Statesman Tech Bulletin TB11

Date Issued: August 25, 2005

Product Affected: Statesman Product Line

UPDATING COLOR STATESMAN REV "B" PCB

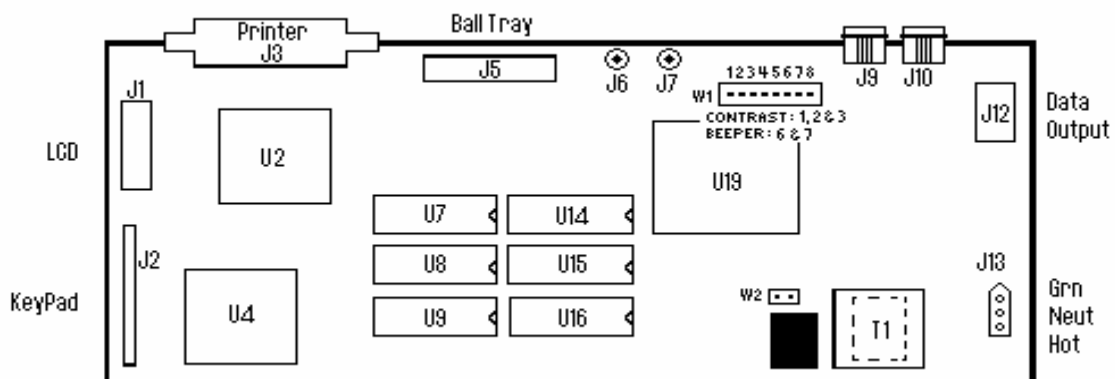
3. Remove cable J5 to allow clear visibility.
4. Using a small jewelers screwdriver or pocket knife carefully remove the IC labeled 469011 or 4690110 from U7.

5. Carefully insert the new chip labeled 4690130 CL3.0 or 4690131 CLR3.0 into U7 making sure the notch and open holes are towards the transformer. Be Careful NOT to bend the pins.

6. Using a small jewelers screwdriver or pocket knife carefully remove the IC labeled 469015 from U8. Insert chip labeled 4690150 REV 1.0 into U8 making sure the notch is toward the transformer and none of the pins are bent.

7. Using a small jewelers screwdriver or pocket knife carefully remove the IC labeled 469016 from U15. Insert chip labeled 4690160 REV1.0 into U15 making sure the notch is toward the transformer and none of the pins are bent.

8. Using a small jewelers screwdriver or pocket knife carefully remove the IC labeled 469017 from U9. Insert chip labeled 4690170 REV 1.0 into U9 making sure the notch is toward the transformer and none of the pins are bent.

9. Using a small jewelers screwdriver or pocket knife carefully remove the IC labeled 469018 from U16. Insert chip labeled 469019 REV 1.0 into U16 making sure the notch is toward the transformer and none of the pins are bent.

UPDATING DESIGNER STATESMAN REV "B" PCB

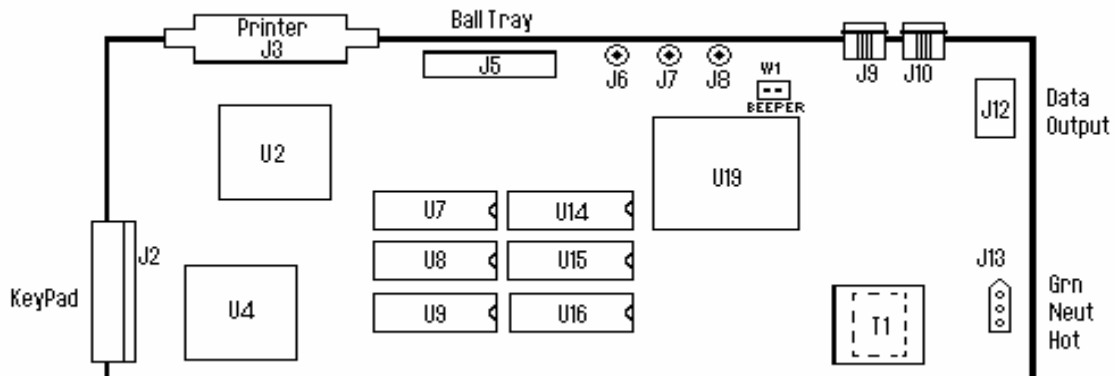
3. Remove the six Phillips screws securing the cover of the I/O box.
4. Remove cable J5 to allow clear visibility.
5. Using a small jewelers screwdriver or pocket knife carefully remove the IC labeled 469012 or 4690120 from U7.

6. Carefully insert the new chip labeled 4690132 VS3.0 or 4690133 VSR3.0 into U7 making sure the notch and open holes are towards the transformer. Be Careful NOT to bend the pins.

7. Using a small jewelers screwdriver or pocket knife carefully remove the IC labeled 469015 from U8. Insert chip labeled 4690150 REV 1.0 into U8 making sure the notch is toward the transformer and none of the pins are bent.

8. Using a small jewelers screwdriver or pocket knife carefully remove the IC labeled 469016 from U15. Insert chip labeled 4690160 REV1.0 into U15 making sure the notch is toward the transformer and none of the pins are bent.

9. Using a small jewelers screwdriver or pocket knife carefully remove the IC labeled 469017 from U9. Insert chip labeled 4690170 REV 1.0 into U9 making sure the notch is toward the transformer and none of the pins are bent.

10. Using a small jewelers screwdriver or pocket knife carefully remove the IC labeled 469018 from U16. Insert chip labeled 469019 REV 1.0 into U16 making sure the notch is toward the transformer and none of the pins are bent.

UPDATING COLOR STATESMAN REV "C" PCB

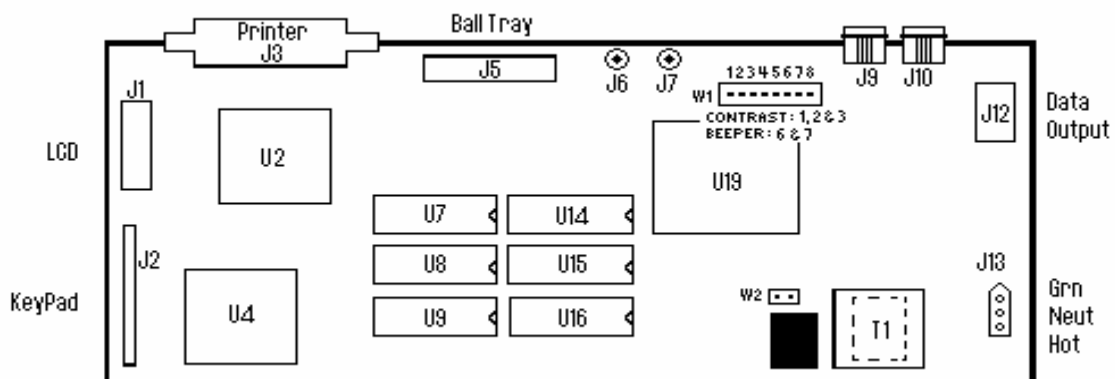
3. Remove cable J5 to allow clear visibility.
4. Using a small jewelers screwdriver or pocket knife carefully remove the IC labeled 4690112 or 4690113 from U7.

5. Carefully insert the new chip labeled 4690115 CS5.0 or 4690116 CSR5.0 into U7 making sure the notch and open holes are towards the transformer. Be Careful NOT to bend the pins.

6. Using a small jewelers screwdriver or pocket knife carefully remove the IC labeled 469015 from U8. Insert chip labeled 4690150 REV 1.0 into U8 making sure the notch is toward the transformer and none of the pins are bent.

7. Using a small jewelers screwdriver or pocket knife carefully remove the IC labeled 469016 from U15. Insert chip labeled 4690160 REV1.0 into U15 making sure the notch is toward the transformer and none of the pins are bent.

8. Using a small jewelers screwdriver or pocket knife carefully remove the IC labeled 469017 from U9. Insert chip labeled 4690170 REV 1.0 into U9 making sure the notch is toward the transformer and none of the pins are bent.

9. Using a small jewelers screwdriver or pocket knife carefully remove the IC labeled 469018 from U16. Insert chip labeled 469019 REV 1.0 into U16 making sure the notch is toward the transformer and none of the pins are bent.
